Date of decision: 29 September 2017

**MINOR CORRECTIONS TO DECISIONS REGARDING CHAPTERS 6 AND 14**

**JOINT MEMORANDUM OF COUNSEL FOR CHRISTCHURCH CITY COUNCIL AND  
CHRISTCHURCH INTERNATIONAL AIRPORT LIMITED SEEKING MINOR  
CORRECTIONS TO CHAPTER SIX AND CHAPTER 14 OF THE CHRISTCHURCH  
REPLACEMENT DISTRICT PLAN**

**17 August 2017**

### Current (incorrect) Figure 1 in Rule 6.1.6.2.5

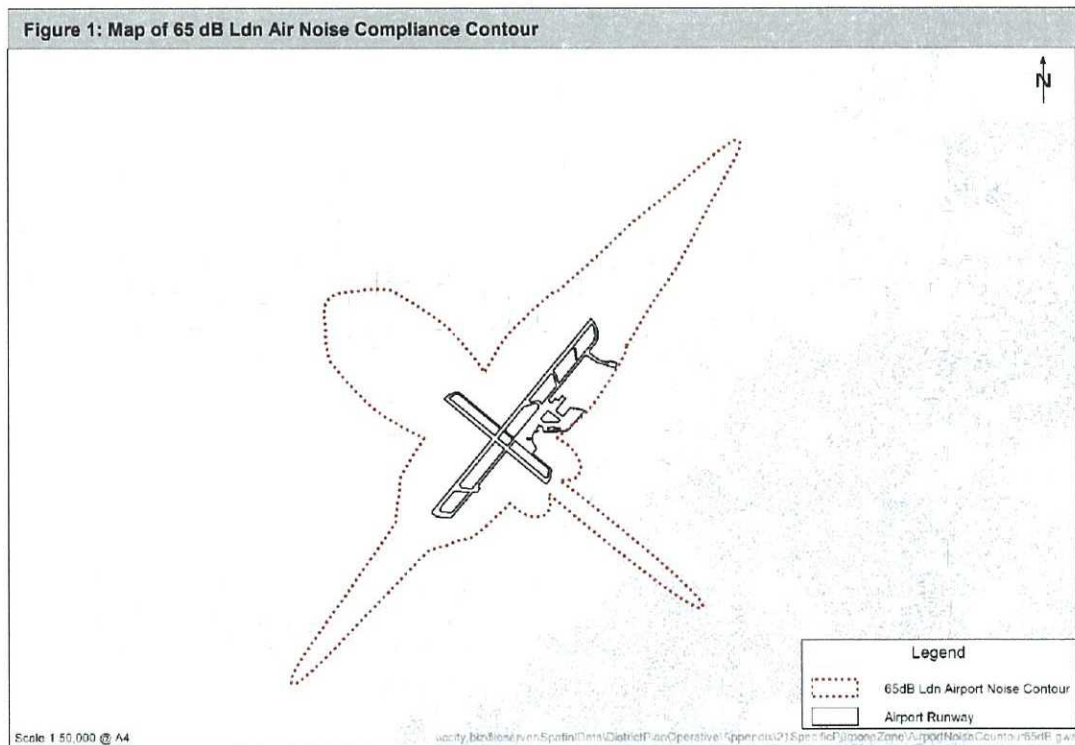
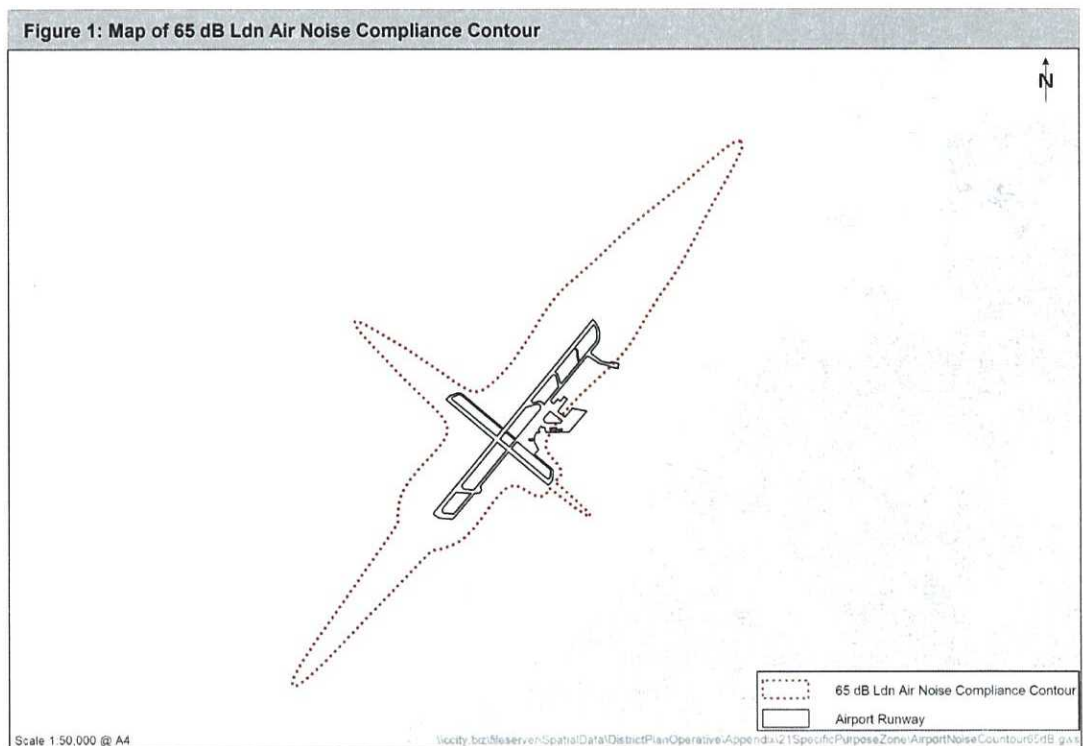
[17] A correction is requested to Figure 1 in Rule 6.1.6.2.5 on the basis that it:

incorrectly shows the composite 65dB Ldn / 95dB LAe contour (65/95dB Contour), rather than the 65dB Ldn Air Noise Compliance Contour (65dB Contour), which is the focus of Rule 6.1.6.2.5.<sup>12</sup>

[20] In this case all that has occurred is that Figure 1, which is referenced in Rule 6.1.6.2.5, whilst correctly titled ‘Map of 65dB Ldn Air Noise Compliance Contour’, incorrectly

illustrates the 65/95dB Contour rather than the 65dB Contour. The error was made by the Council when updating planning maps and figures to reflect Decision 57, which was overlooked by the Panel when confirming those updates.

8. Figure 1 in Rule 6.1.6.2.5<sup>5</sup> requires correction as it incorrectly shows the composite 65dB L<sub>dn</sub> / 95dB L<sub>Ae</sub> contour (**65/95dB Contour**), rather than the 65dB L<sub>dn</sub> Air Noise Compliance Contour (**65dB Contour**), which is the focus of Rule 6.1.6.2.5.
9. Figure 1 was notified as part of Stage 2 in May 2015 and showed the correct 65dB Contour. This Figure was submitted on by CIAL in submission 2348.56, seeking wording amendments to the notified title, but there was no request to

12. The Council has contacted CIAL who have agreed that the current Figure 1 is incorrect. CIAL have therefore signed this memorandum.
13. A current (incorrect) and corrected Figure 1 are both included in **Appendix 1** to clearly show the implications of the corrected 65/95dB Contour. The key in Figure 1 has also been amended to match the title as amended by the decision, which is a minor correction to ensure consistency and coherency of the rule and figure. The Council respectfully seeks that the Panel corrects its Minor Corrections and Consistency Changes to Decisions 11, 23, 24 and 57 decision to include the corrected Figure 1, as this is an error mistakenly included in the CRDP.

- (b) They were supportive of the proposed clarification of the commencement dates for the Chapter 6 Airport Rules; and
- (c) They have no comment to make with regards to the changes requested to Chapter 14 minimum building setback; and

### Corrected Figure 1 in Rule 6.1.6.2.5

Extract from Council's Memorandum seeking minor corrections to the CRDP dated 19 May 2017 showing the corrections sought to Rules 14.4.2.7 a, 14.7.2.5 a, and 14.9.2.5 a

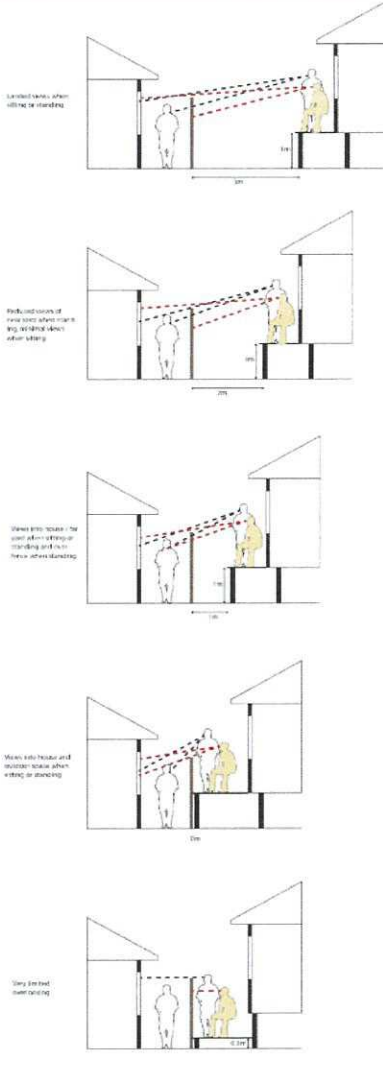
Provision was provided for buildings to be raised to reduce risks from flooding. In some cases this could result in a residential building being raised to have a ground floor level of 1.5m (or higher). As a consequence an adjoining deck or terrace may need to be raised to provide ease of access from indoors to outdoors. The rule on internal boundary setbacks was however never reconsidered, specifically the zero setback allowance for decks and terraces at ground floor level (which the Council has established could be as high as 1.5m or greater under the current rule).

The illustrations below depict the impact the current rule has on the adjoining resident's privacy. It is recommended that decks and terraces should be able to extend from ground floor level, however within a 1m building setback, should not exceed a height of 300mm above ground level. As demonstrated in the illustrations below, this will ensure a reasonable level of privacy is maintained by the adjoining neighbour, whilst still ensuring the plan user is not disadvantaged in any way, i.e. is able to build a feasible and compliant deck or terrace.

PROVISION	CORRECTION		
14.4.2.7 a.	iii.	Decks and terraces at or below ground <b>floor</b> level to a maximum height of 300mm above ground level within 1m of the boundary.	Nil
14.7.2.5 a.	iii.	Decks and terraces at or below ground <b>floor</b> level to a maximum height of 300mm above ground level within 1m of the boundary.	Nil

14.9.2.5 a.			
v.	Decks and terraces at or below ground <u>floor</u> level to a maximum height of 300mm above ground level within 1m of the boundary.	Nil
